CHANCE
MANUFACTURING CO., INC.

Ride: YO YO

Subject: GUSSET PLATE ADDITION

SERVICE BULLETIN

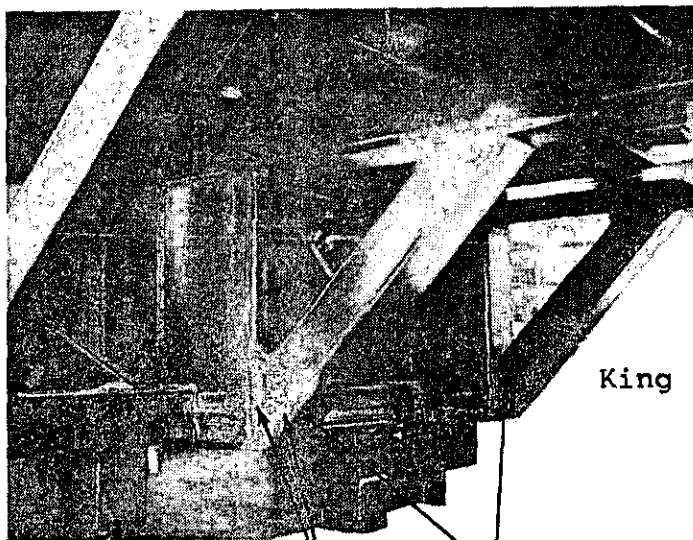
Because of a combination of factors, among them rough road conditions, one area of the YO YO trailer is receiving a higher degree of stress than was expected. This has resulted in the partial failure of the weld joints.

As soon as we receive the enclosed card from you, we will ship eight gusset plates which should be added to the trailer as shown.

It is important that these gusset plates be added even though your trailer presently shows no signs of fatiguing.

3/8 inch Fillet Weld-two sides-
E70XX Rod

Weld gusset plates on both
side of tube

Subject: CHAIR CHAIN SHACKLE INSPECTION AND
BOLT REPLACEMENT

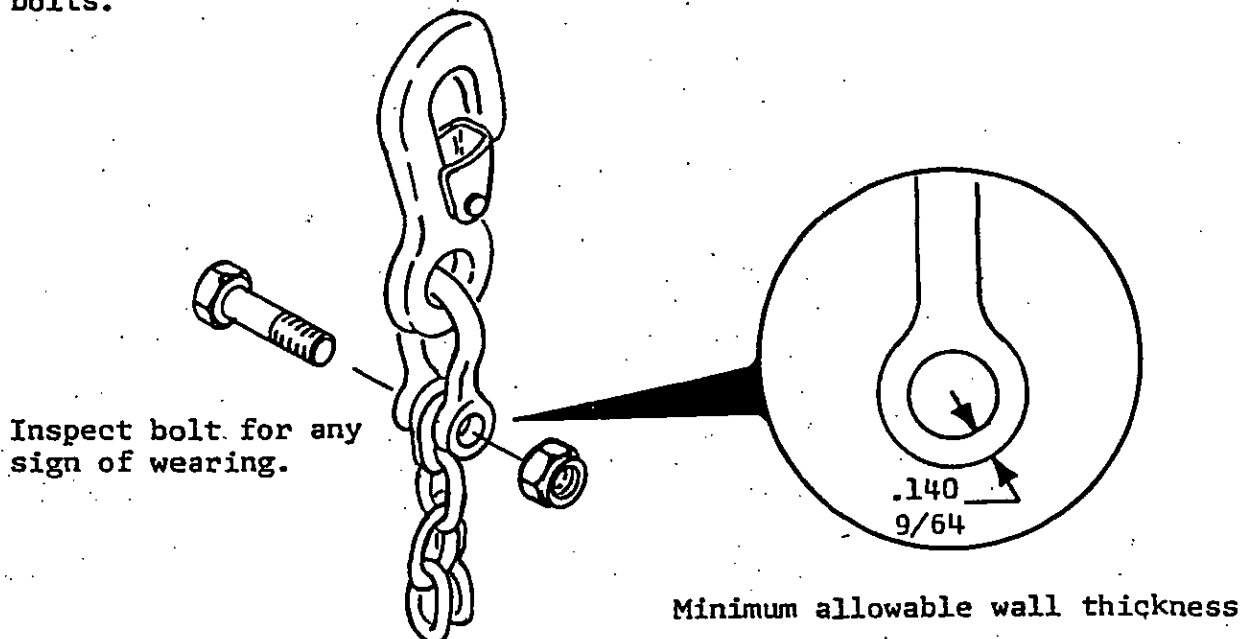
As a safety precaution, all Y0 Y0 owners are being asked to inspect the Shackles securing the chair support chain to the Snap Hook.

Because of manufacturing tolerances in the Shackles, the wall thickness of the eyes will vary. As a result of this condition, it has become necessary to specify a minimum wall thickness to insure an adequate safety factor.

All Y0 Y0 owners should check each Shackle, replacing any not meeting the minimum wall thickness requirements.

As the bolts are removed, they should be checked for any sign of wear. If wear is indicated, they should be replaced with 3/8-16 x 2" long Grade 5 bolts.

Shackles not meeting minimum wall thickness will be replaced, upon notification of factory.

REAR ERECTION CYL. MOUNT

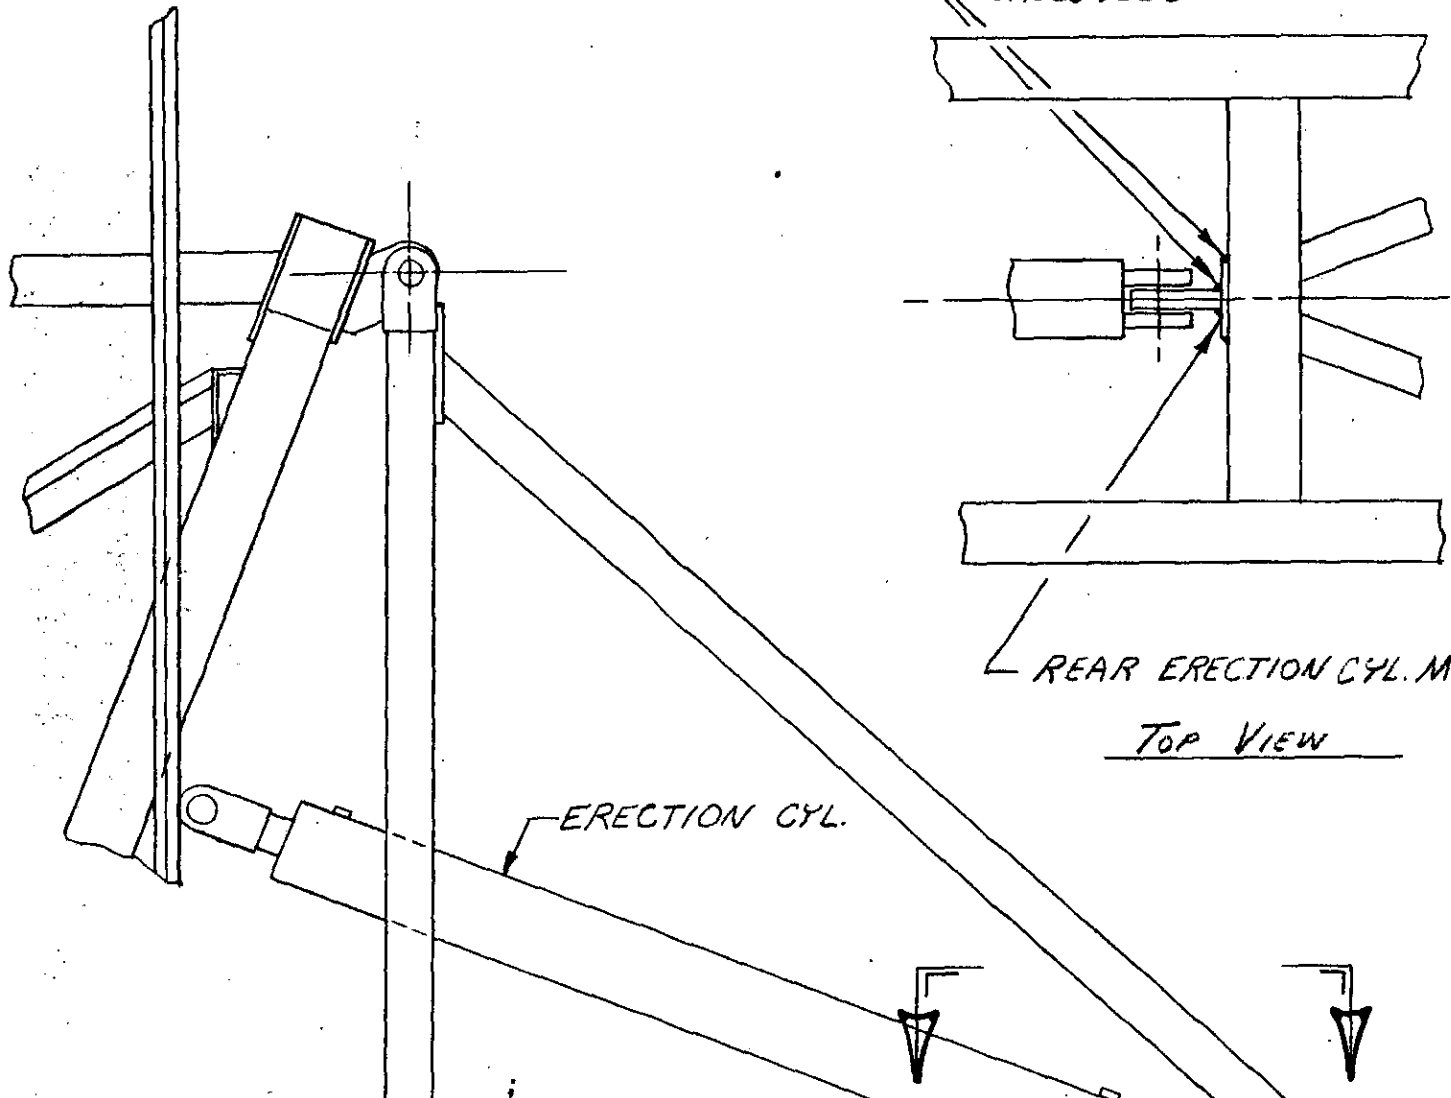
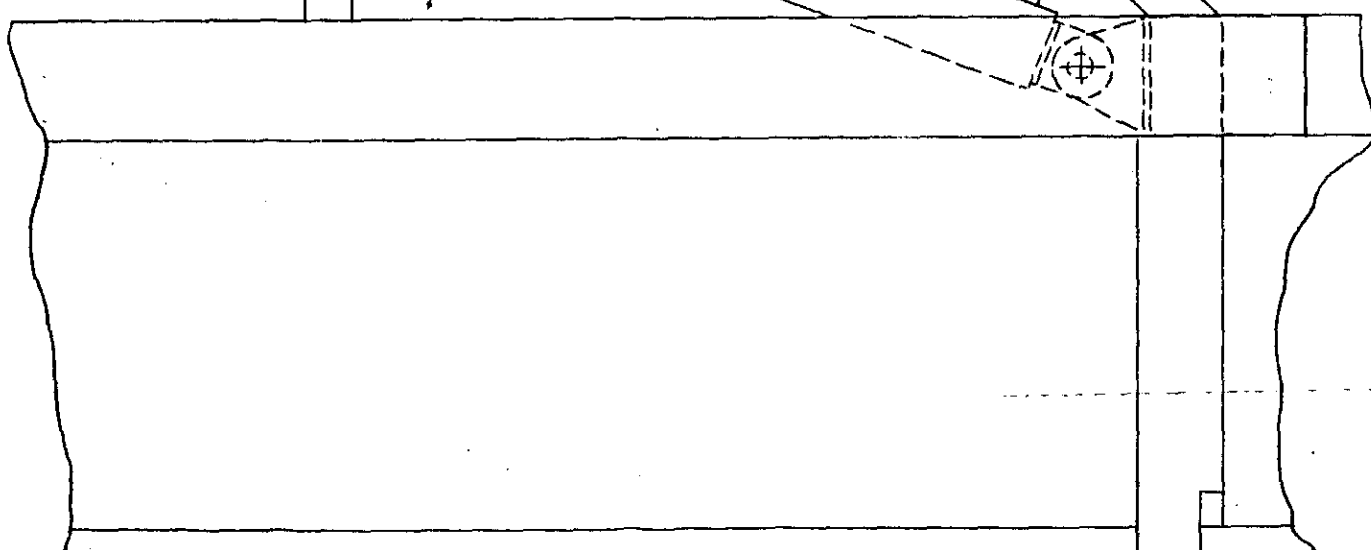
Recently we have become aware of a condition on the YO YO Ride that could cause a serious accident. The problem is in the area of the tower erection cylinder mount, shown on the back of this sheet. If your ride personnel reverse the direction of the tower lift cylinder with the tower stiff leg brace pinned in position, it may tear the rear erection cylinder mount off the trailer frame. This will allow the tower to fall when the pin is removed, which would have catastrophic results.

It is imperative that you check the rear erection cylinder mount immediately to see that it has not been broken or cracked. Also, you must alert your ride personnel as to this condition so they will not reverse the direction of the erection cylinder until the tower stiff leg pin has been removed.

CHECK ALL WELDS AROUND
EAR & DOUBLER PLATE FOR
CRACKS & BULGING OF 6"x10"
CROSS TUBE

In order to eliminate the possibility of this condition occurring, we are making a change in the hydraulic circuit that operates the tower erection cylinder. Please contact Richard G. Chance at the factory so we can schedule a service representative to make this change on your ride. This change will be made at no cost to you, and it is very important that you contact us immediately.

Subject: CYLINDER END CAP CHECK AND
REPLACEMENT

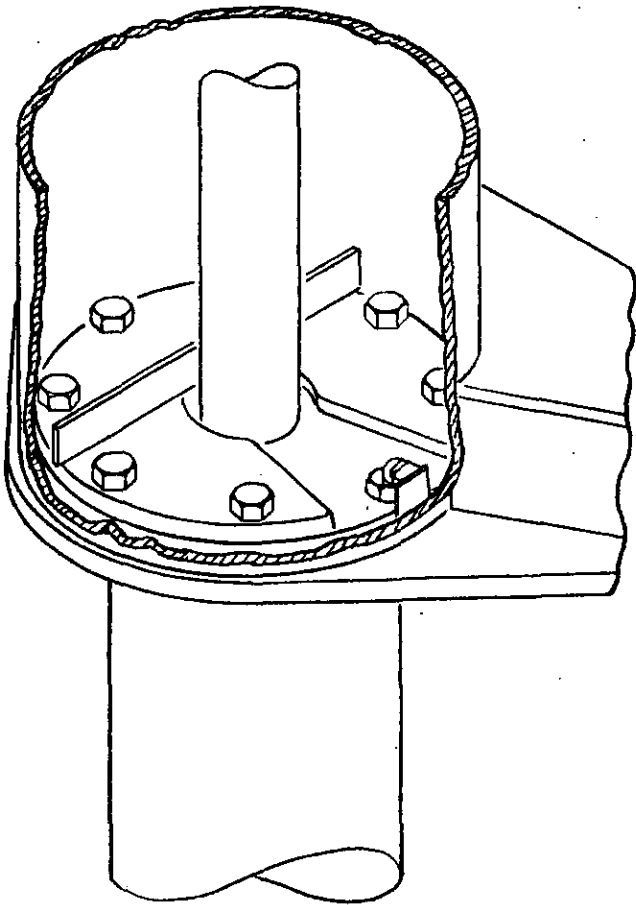
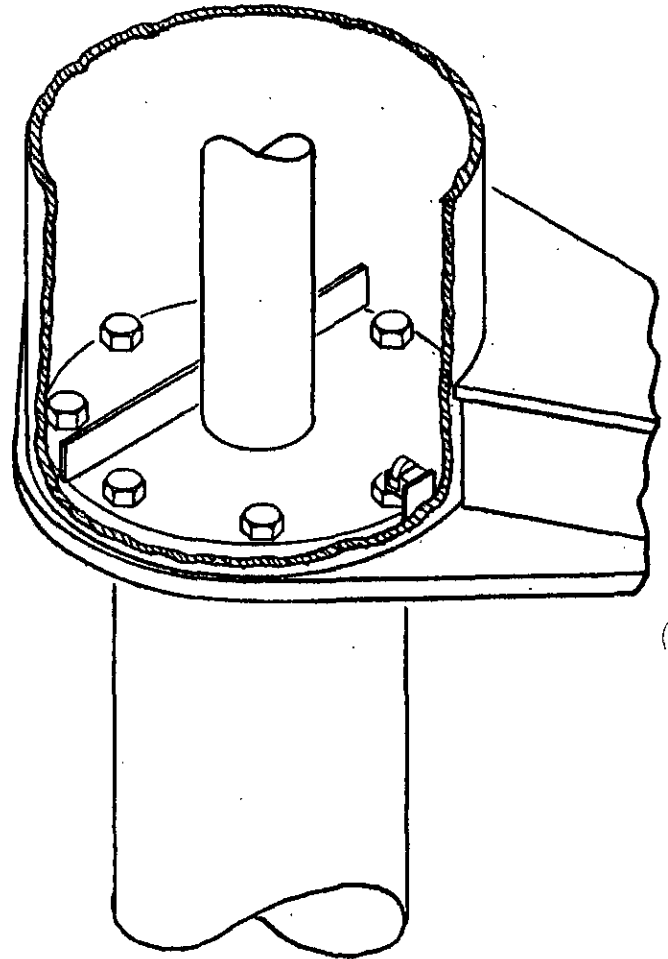
Due to a sweep lift cylinder end cap having blown out on a Y0 Y0, we have had tests performed by an outside testing firm. The failure was determined to be due to an overloading of the hydraulic system. To prevent further incidents, maximum hydraulic pressure settings should not be exceeded and a new cylinder end cap installed. There is a hydraulic schematic for your ride attached to this bulletin. Rides 74-3300 through 75-3333 have had a temporary kit installed on the end cap which should serve through the remainder of the season. Rides 75-3333 through 76-3342 have been operating less than one season and should serve until the new design end cap can be installed at the end of this season.

Place a straight edge across the end cap as shown in drawing. Check in at least two positions, 90° apart. Try to insert a 1/16" feeler gauge under straight edge. If end cap shows more than 1/16" gap, notify factory at once.

New stronger design end caps will be available from the cylinder manufacturer for all rides through 76-3342 by mid-July. Make appointments for installation of these kits with Dick Chance as soon as possible. If you are in our area, installation is available at the factory. This installation will be much faster than road service, which is also available.

FIGURE B
INSPECT ALL WELDS
AROUND EAR AT TOP
OF CYLINDER

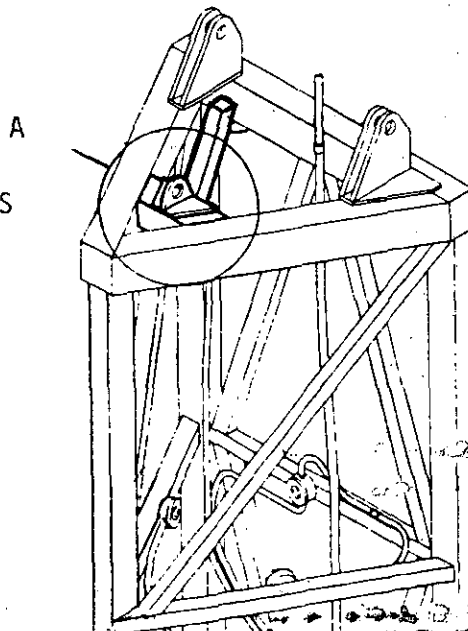
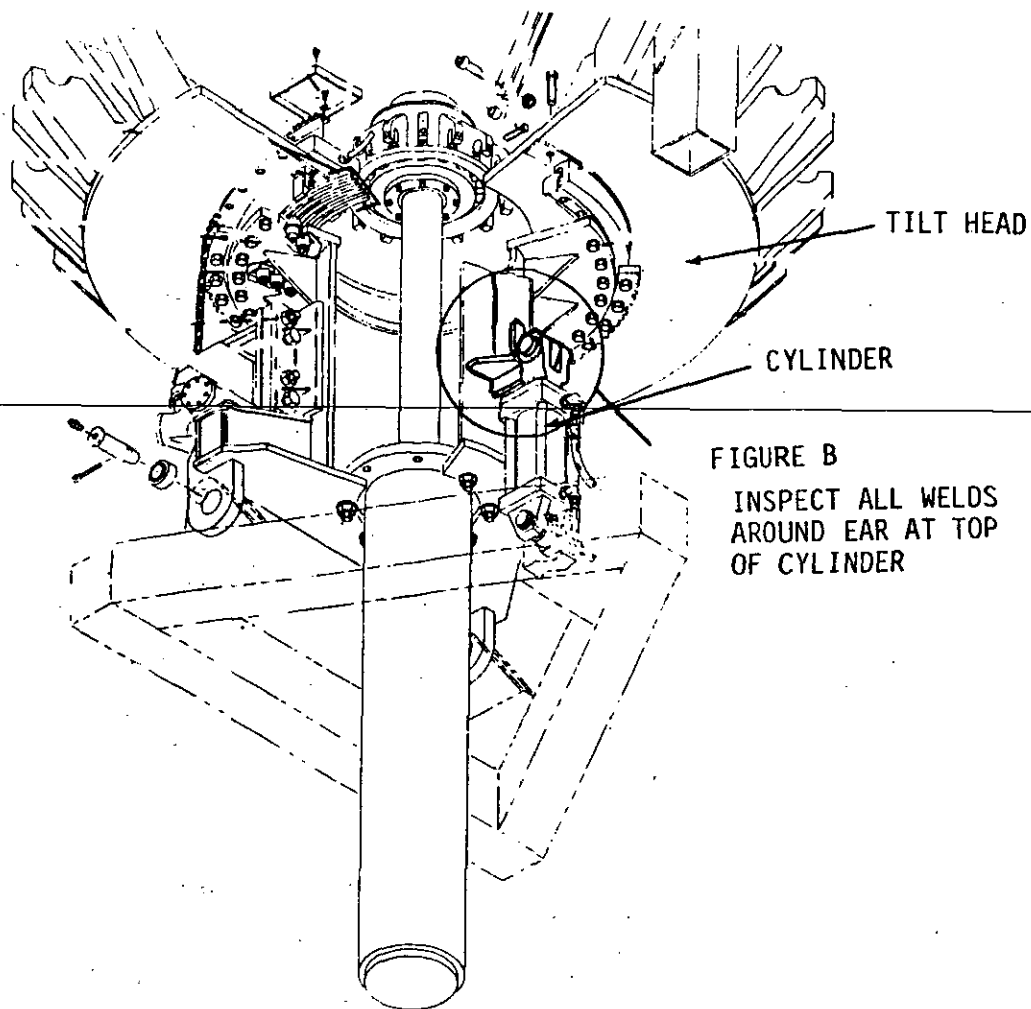
A condition has occurred on one ride in which the bottom ear fastening the tilt cylinder to the top of the tower, tore loose. We are requesting that all owners of Yo Yo's immediately inspect the weld and metal adjacent to the weld on the ear attached to the tower, (FIGURE A). The ear at the top of the cylinder attached to the tilt head, (FIGURE B). and the leveling stop tube where it attaches to the tower (FIGURE C), should also be checked.

Please report the presence of cracks at areas "A", "B", or "C" immediately to Chance Manufacturing Co., Inc.

INSPECT ALL WELDS
IN THIS AREA

These areas should be established as "Special Care Areas" and given regular weekly visual inspections by qualified individuals.

Subject: Lap Bar Kit

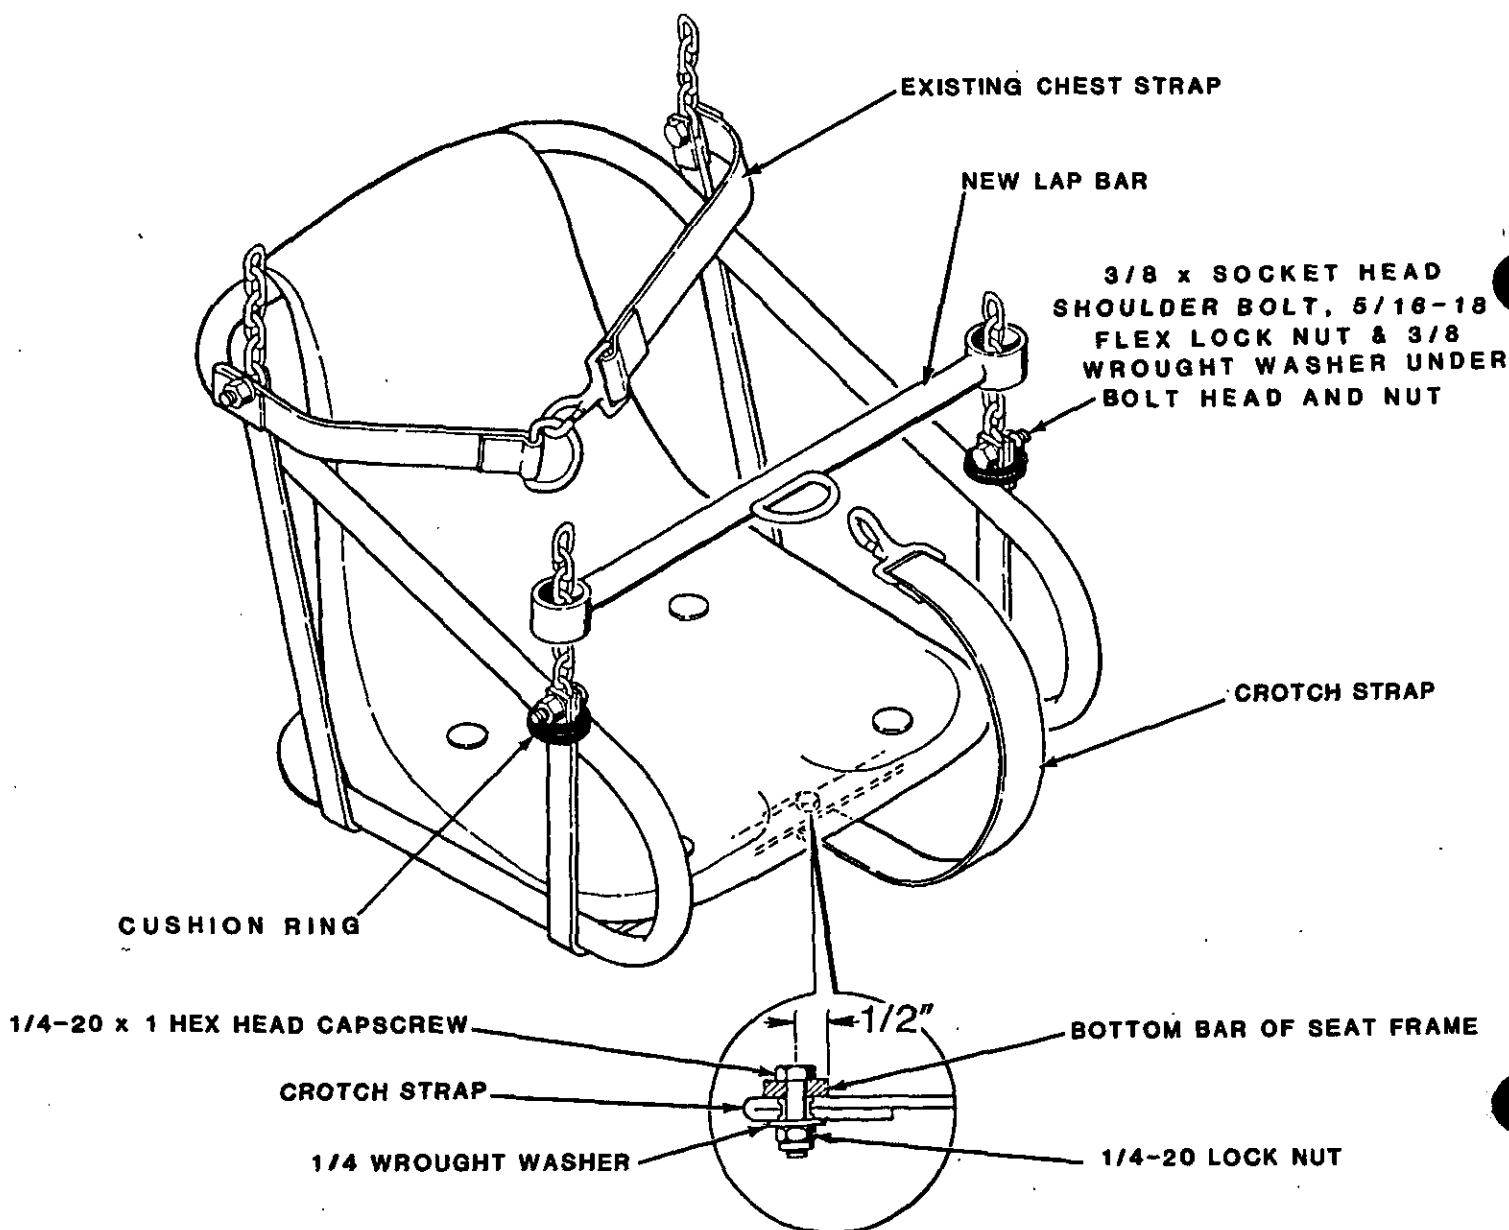
CHANCE MANUFACTURING CO., INC. has become aware of at least one accident involving the YO YO amusement ride. The passenger apparently was pulled by another passenger and/or slid forward under the lap bar and out of the seat while the ride was in motion.

CHANCE MANUFACTURING has developed a new lap bar which increases passenger safety. The new lap bar design incorporates a crotch strap, which secures the lap bar in the lowered position. The existing chest strap must be used in conjunction with the new lap bar to complete the passenger restraint system.

ALL OWNERS OF YO YO RIDES ARE REQUIRED TO REPLACE THE EXISTING LAP BARS WITH THE NEW LAP BAR SYSTEM.

Order kit number K61-0263-00, which includes the new style lap bars, crotch straps and all necessary hardware for one complete ride (32 seats). Install the kit using the instructions on the reverse side of this bulletin. Fill out and return the attached Certification of Compliance for installation of the kit within seven (7) days from receipt of the kit.

Subject: Chair Hanger Wear Limits

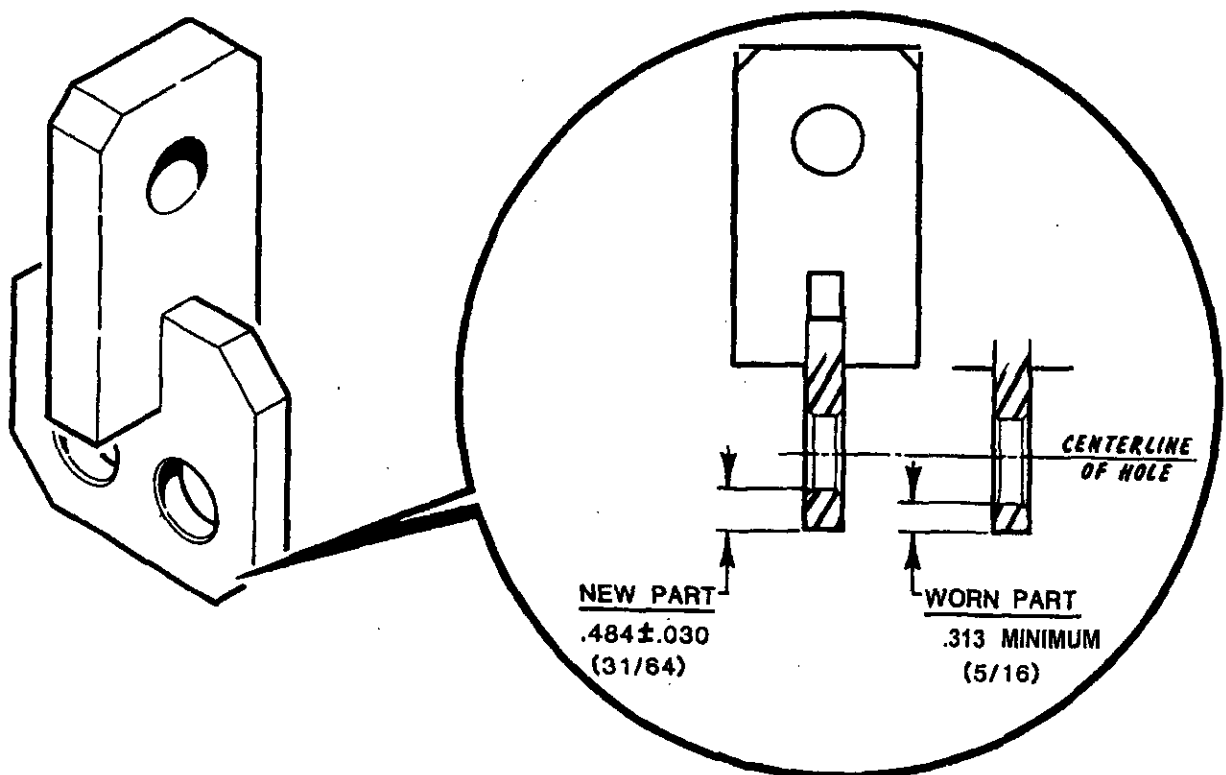
Measure the edge distance on all chair hangers as shown. If the dimension is less than .313 (5/16"), do not operate the ride until the chair hanger is replaced.

New chair hangers are available from CHANCE RIDES, INC. Order part number 361-32706.
